Addendum No. 02
To Contract Documents for Construction

DATE 7/11/2025
PROJECT BP-01 Infrastructure Upgrades
CLIENT Lawrence County Hospital
BWBR COMM. # P.2400141.01

Addendum No. 02
To Contract Documents for Construction
Specialized Engineering Solutions

DATE 7/11/2025
 PROJECT BP-01 Infrastructure Upgrades
 CLIENT Specialized Engineering Solutions
 BWBR COMM. # P.2400141.01

Comm. No. P240014100
Sheet Title: ROOF PLAN, ROOF INFORMATION, EXTERIOR DETAILS
Sheet No.

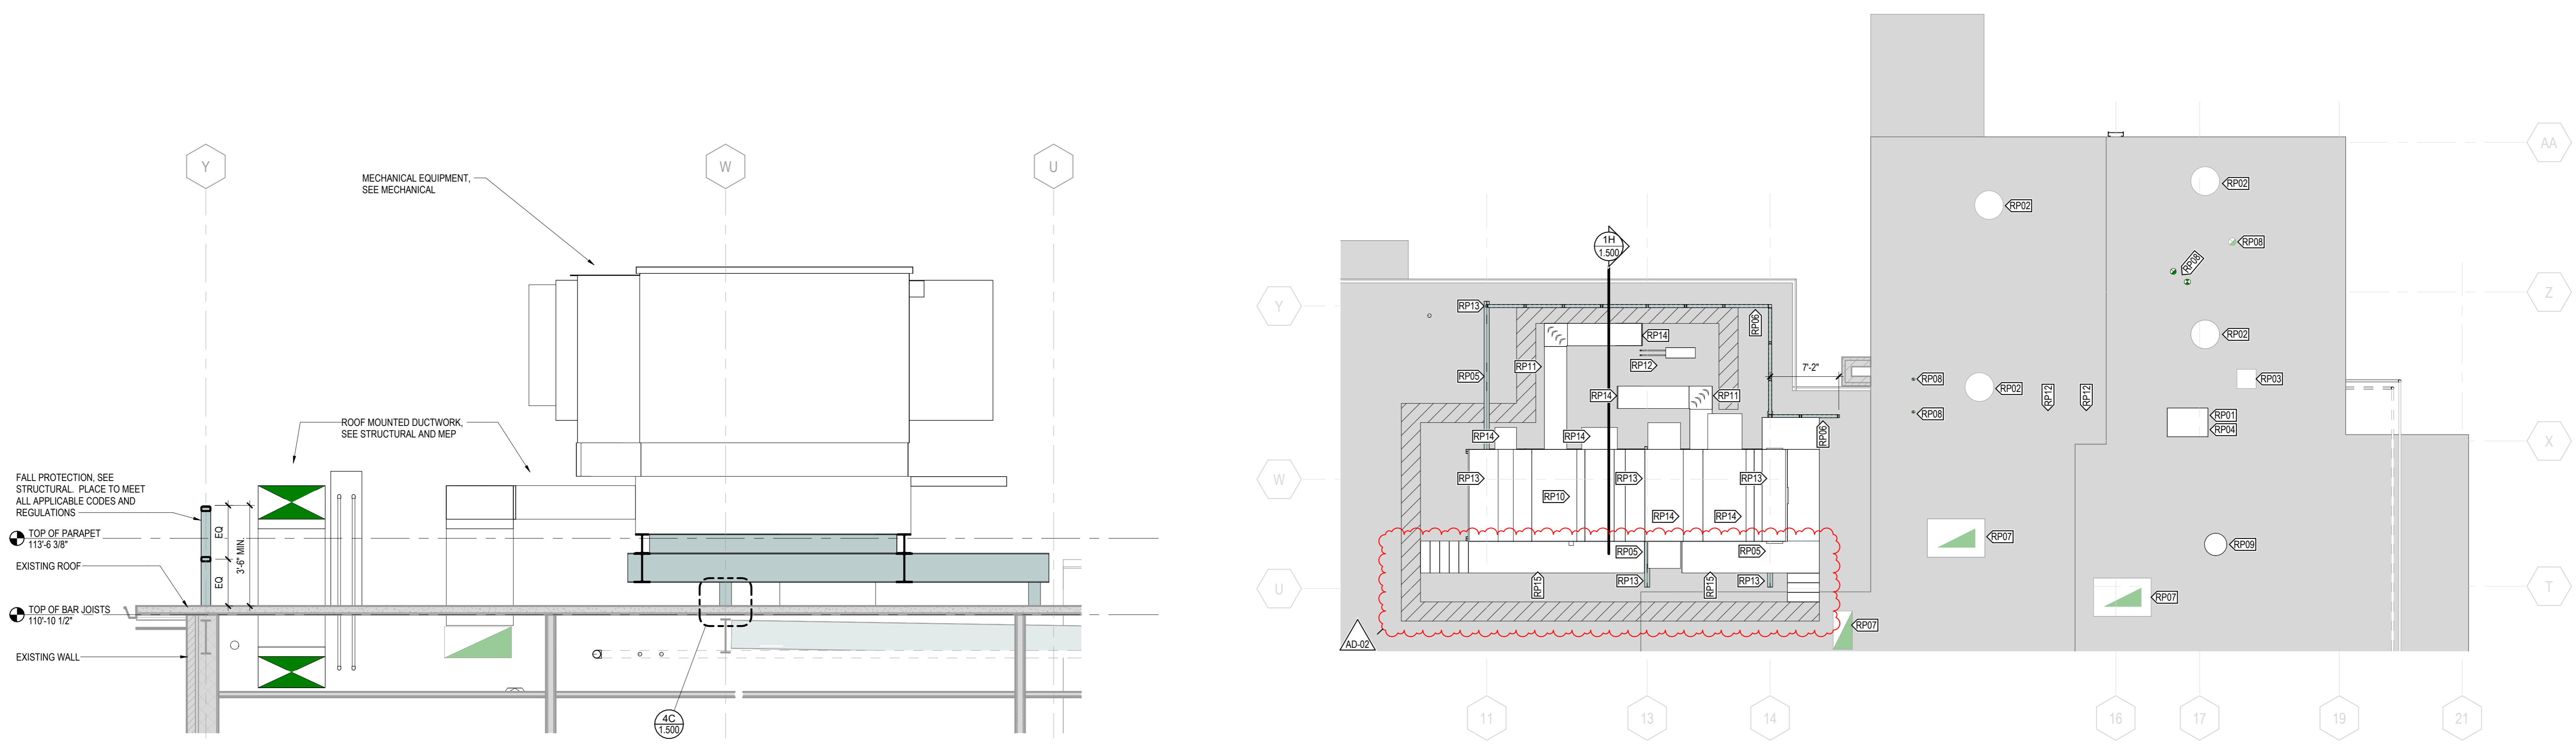
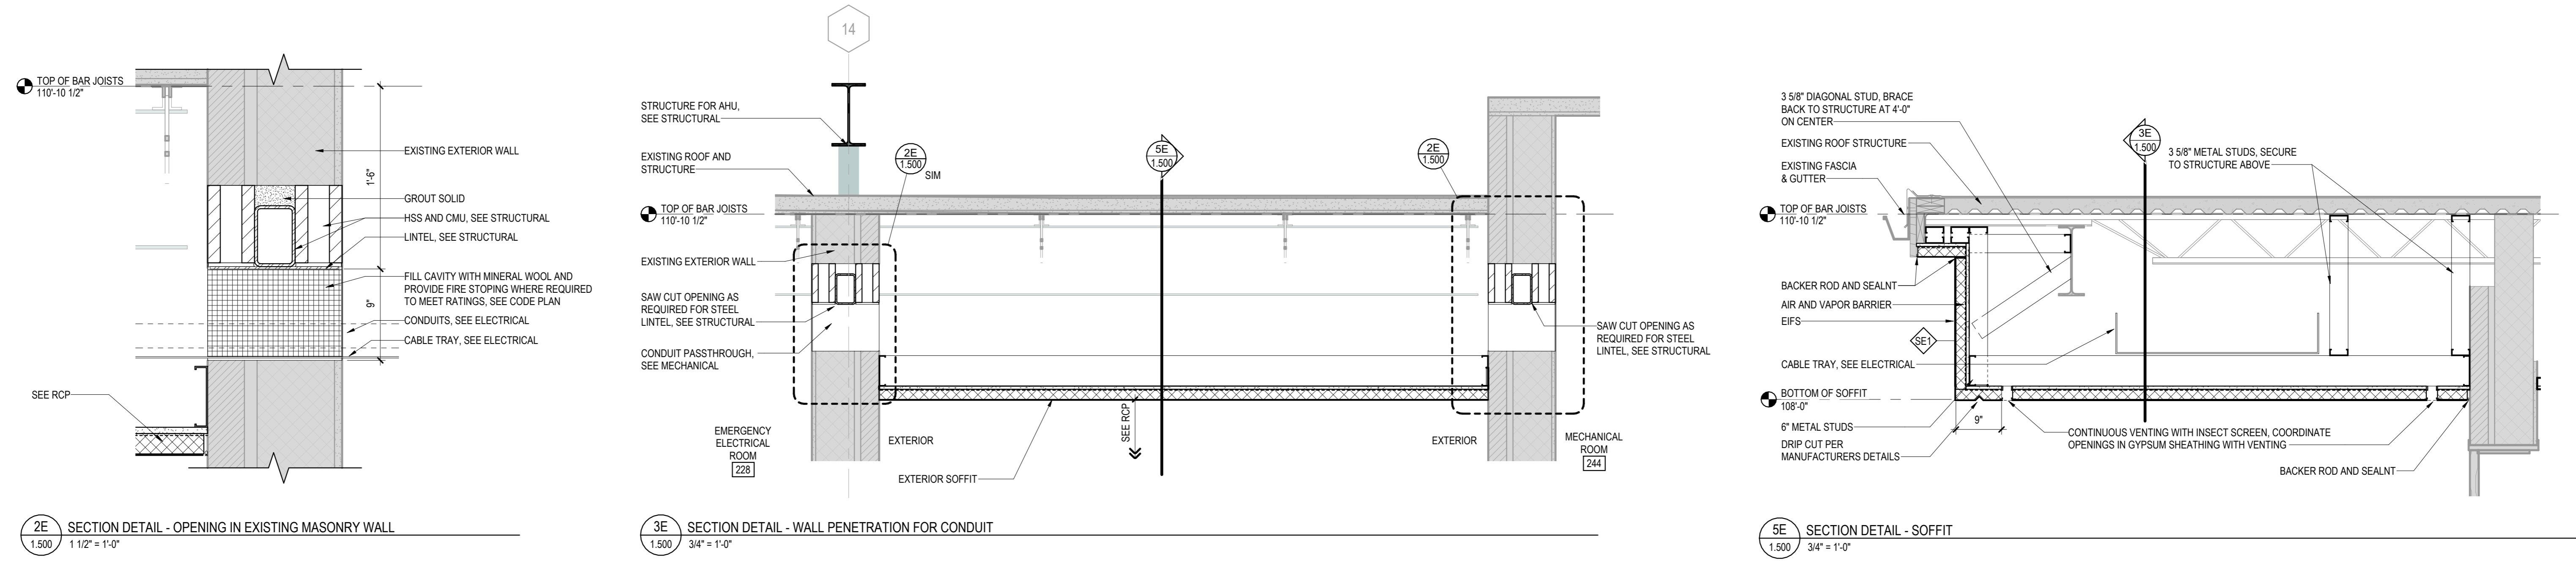
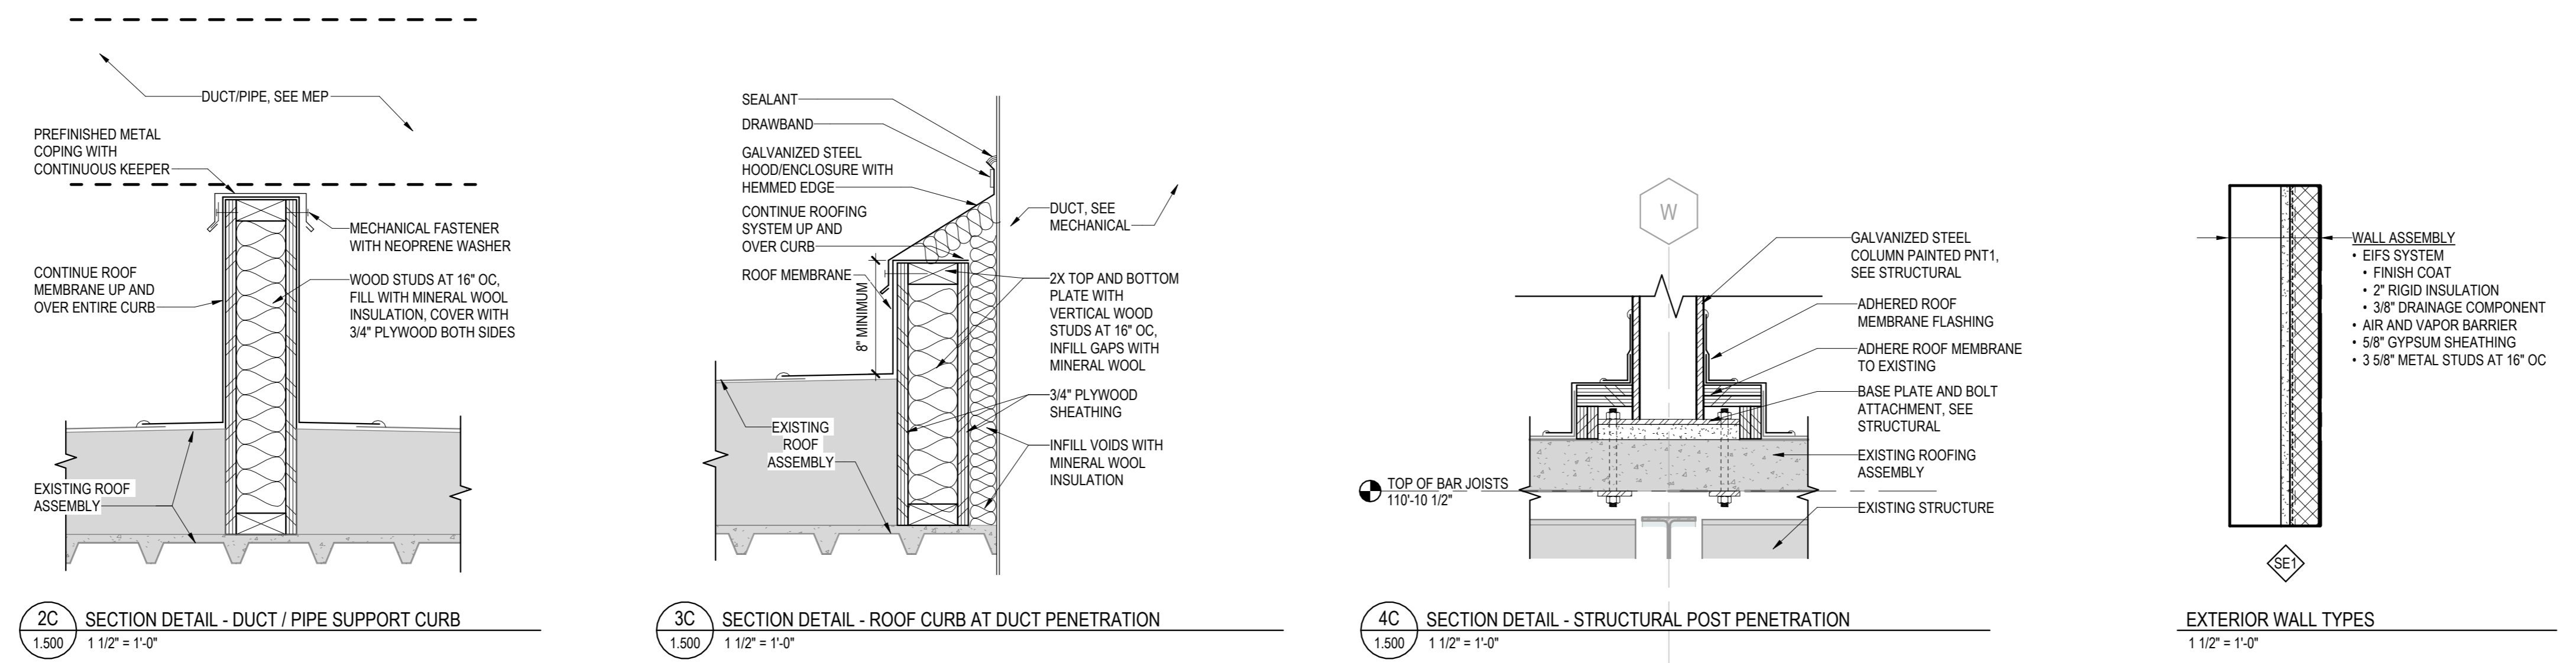
1. Sheet 1.500 – Roof Plan, Roof Information, Exterior Details (Reissued)
 - A. Revise walkway path on roof plan to reflect Mechanical changes.

Sheet Title
ENLARGED PLANS

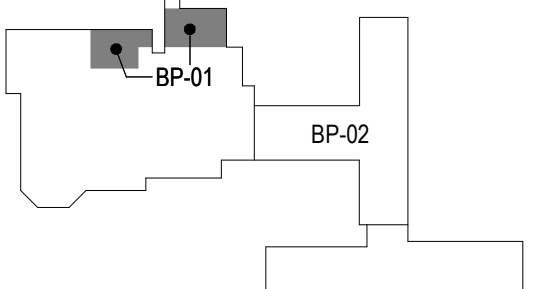
1. **Sheet 1.832 – ENLARGED PLANS (Reissued)**
 - A. Added service platforms for AHU-1.
 - B. Added sheet note 8.
 - C. Revised roof mounted ductwork sizes.
2. **Sheet 1.860 – MECHANICAL SCHEDULES (Reissued)**
 - A. Revised plenum curb height from 36" to 24" for AHU-1.

- PROVIDE 3'-0" WIDE ACCESS PLATFORM ALONG THE AIR HANDLING UNIT. TOP OF ACCESS PLATFORM SHALL BE 4'-6" ABOVE TOP OF ROOF AND EVEN WITH THE TOP OF THE PLENUM CURB. PROVIDE WITH 42" TALL OSHA APPROVED HAND RAILS, STEPS UP TO THE PLATFORM, DECK GRATING, AND BASES. HANDRAILS AT THE LOCATIONS OF COILS SHALL BE REMOVABLE FOR REPLACE OF COILS. PLATFORM IS TO BE ABLE TO SIT DIRECTLY ON THE ROOF WITHOUT MODIFICATION OR FASTENING OF EXISTING STRUCTURE. PLATFORM SHALL BE STAINLESS STEEL, MRO SERVICE PLATFORM OR APPROVED EQUAL. PROVIDE SHOP DRAWINGS OF SERVICE PLATFORM FOR REVIEW AND COORDINATION WITH STRUCTURAL STEEL SUPPORTS.
